Chemical: Propazine  
PC Code: 080808  
DP Barcode: D345936

SUBJECT: Transmittal of the Environmental Fate and Effects Division's (EFED) Response to Comments on Data Gaps Identified in the Registration Science Chapter for the Ecological Risk Assessment of Propazine New Use on Sorghum (DP 310326) dated November 2, 2006

Figure 1. Migratory bird pathways over the central United States including the sorghum growing region of the Great Plains (source: <http://www.birdnature.com/flyways.html>)

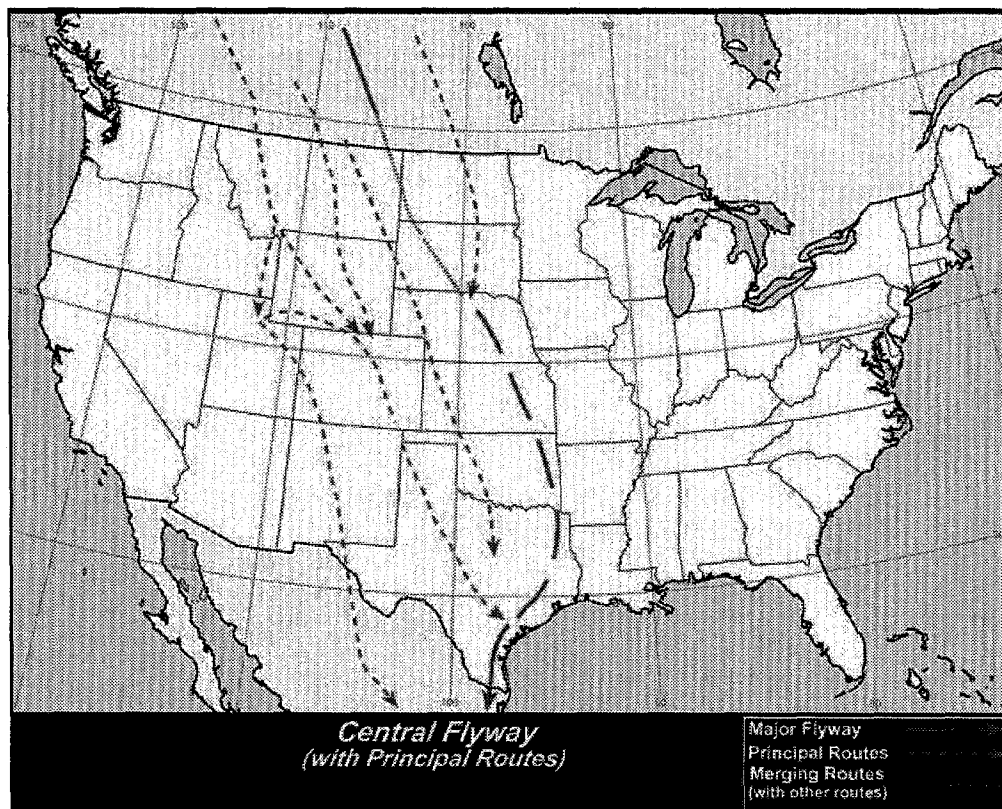
As with the data gap for anaerobic and aerobic aquatic metabolism studies described above the registrant appears to rely on two arguments for not submitting this data. First, the registrant argues that previous documents from the early 1990's did not require these studies and second, they argue that the product will only be applied in arid regions where migratory birds are seldom present and agricultural practices in sorghum preclude exposures. As with the metabolism studies described above, the current Part 158 requirements are that the avian reproduction studies (850.2300) are required for all terrestrial uses, which would include the use of propazine on sorghum. Second, impounded waters are present in the area of sorghum cultivation in Texas, including the arid regions where the registrant is currently conducting a drinking water monitoring study. Also, there is sufficient evidence in the public literature of migratory bird pathways covering this portion of the country as seen in Figure 1. Based on these facts EFED believes these data still represent a data gap.
